**FINAL DRAINAGE REPORT
FOR
SADDLEHORN RANCH – FILING 5 EARLY GRADING**

**August 17, 2023
Project No. 25142.07**

**El Paso County PCD File No.:
EGP226**

EARLY GRADING PROPOSED DRAINAGE MAP
SADDLEHORN RANCH FILING 5
JOB NO. 2514207
8/25/2023
SHEET 2 OF 3

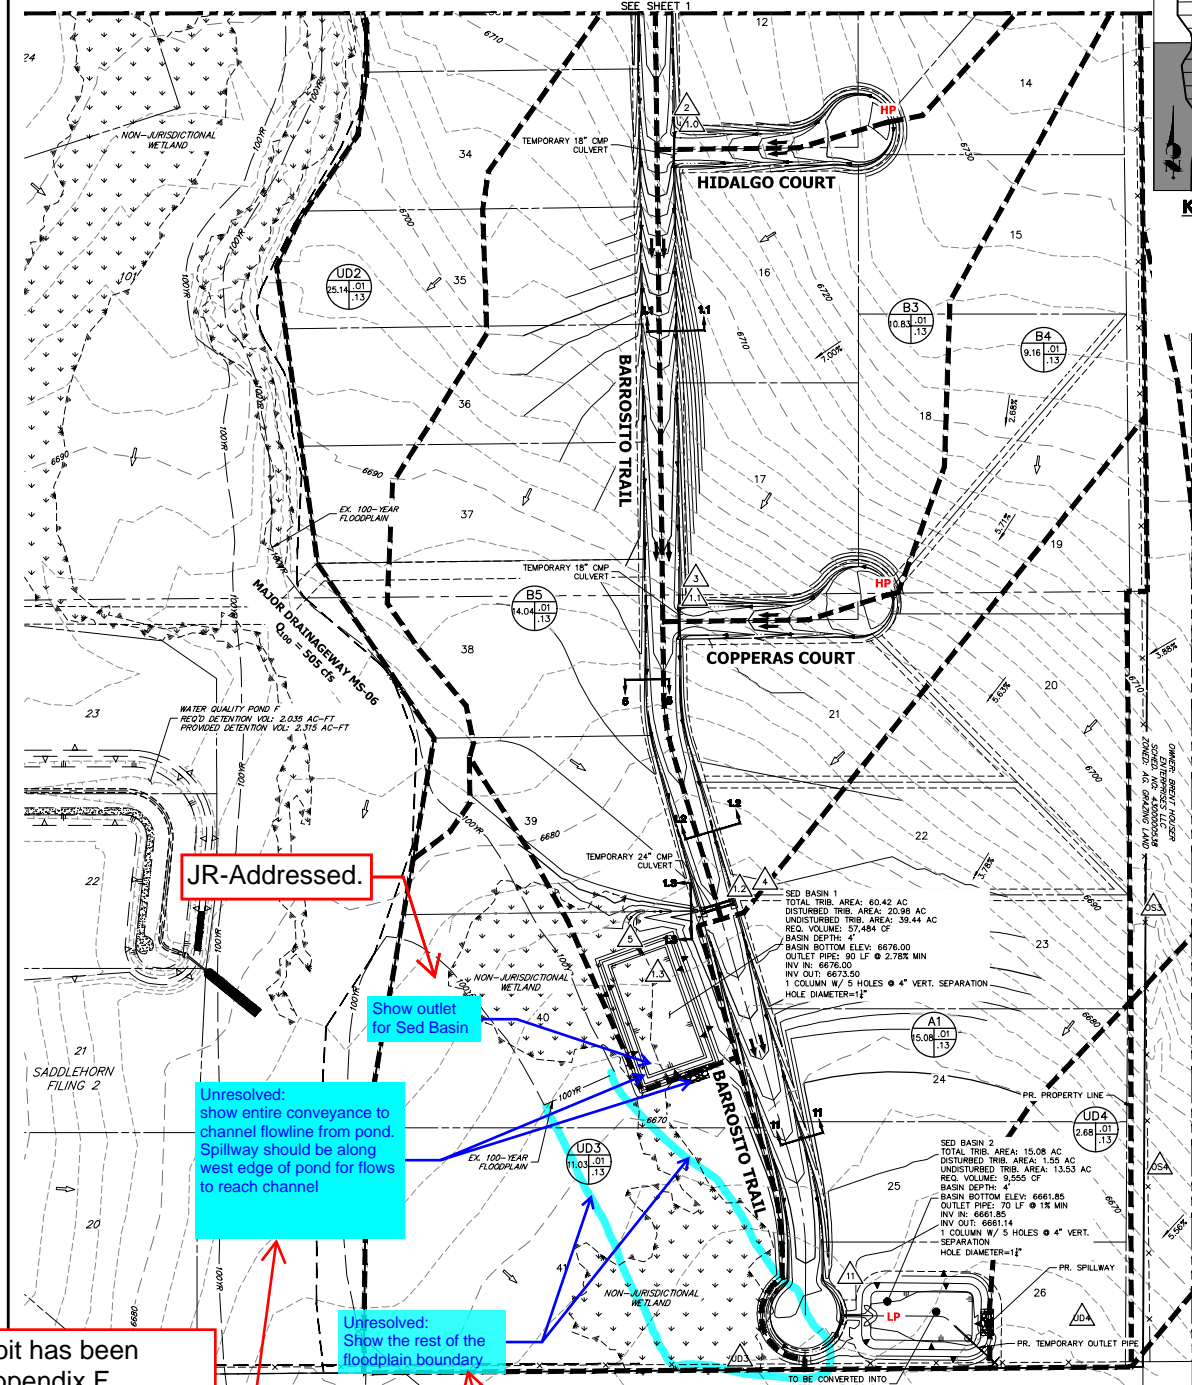
Show outlet for Sed Basin

Unresolved: show entire conveyance to channel flowline from pond. Spillway should be along west edge of pond for flows to reach channel

Unresolved: Show the rest of the floodplain boundary

JR-Addressed.

JR-An exhibit has been added to Appendix F showing the entire conveyance to the channel flowline from both sediment basins. The spillway for the sediment basin has been shifted to the west side.
